Diagnostic Trouble Codes (DTCs), Low Oil Pressure
 VAH, VHD, VN
 D11H, D11J

FSB 221-010, Diagnostic Trouble Codes (DTCs), Low Oil Pressure

(May 2015)

W2084376

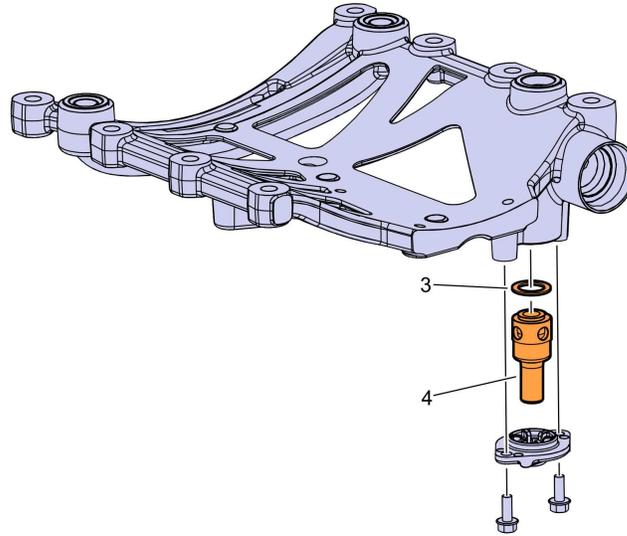
Required Parts			
Item	Part Number	Description	Quantity
3	469846	O-Ring, Internal	1
4	22416685	Pressure Reduction (Relief) Valve, Purple	1

W2006072

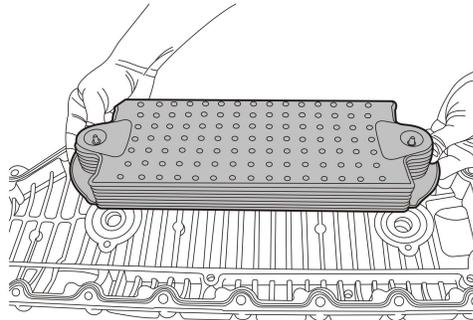
Part Number	Description	Quantity
85125094	Oil Cooler Kit	1
993664	O-Ring (substitute for 40471626 in oil cooler kit)	1
85116577	Turbocharger Installation Kit	1
85124530	EGR Cooler Kit	1

W2103580

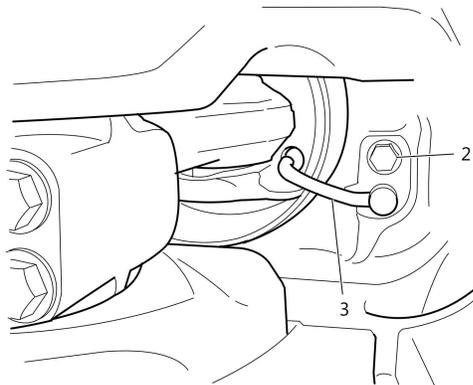
Item Number	Part Number	Description	Quantity
2	994445	M8*16 Piston Cooling Nozzle Screws	6
3	22577447	Piston Cooling Nozzle	6

- 5 Remove and replace the piston cooling nozzles. Refer to Function Group 22. Replace the single use screws. Tighten the new piston cooling nozzle screws to 24 ± 3 Nm (18 ± 2 ft-lb).
- 6 Remove and replace the oil cooler. Refer to Function Group 22.
- 7 Install the oil pan. Refer to Function Group 21.
- 8 Refill the engine oil to the proper level.
- 9 Reconnect all previously removed cables to the negative (ground) battery terminals.
- 10 Reprogram the engine control module if required based on the reference table. Refer to Function Group 28
- 11 Start engine, check for leaks and proper operation. Clear any DTC.

W2082023

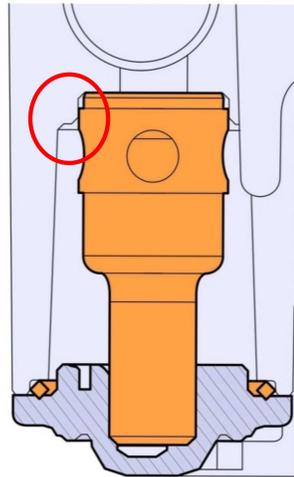
- 1 Secure the vehicle for service by parking it on a flat level surface, applying the parking brake, chocking the rear wheels, and placing the transmission in neutral or park.
- 2 Disconnect all battery cables from the negative (ground) battery terminals to prevent personal injury from electrical shock and prevent damage to electrical components.
- 3 Remove the oil pan. Refer to Function Group 21.
- 4 Remove and replace the pressure reduction (relief) valve in the oil valve body and replace the internal O-ring. Tighten cover fasteners to 10 ± 2 Nm (88 ± 17 in-lbs).

Note: Make sure the valve is fully seated and the cover close to the valve housing prior to threading in the retaining screws. Otherwise the valve can make contact with the edge just ahead of the seating surface and damage the valve. Do not use power tools to install this valve. Do **NOT** disturb the pressure reduction valve located in the oil filter housing.
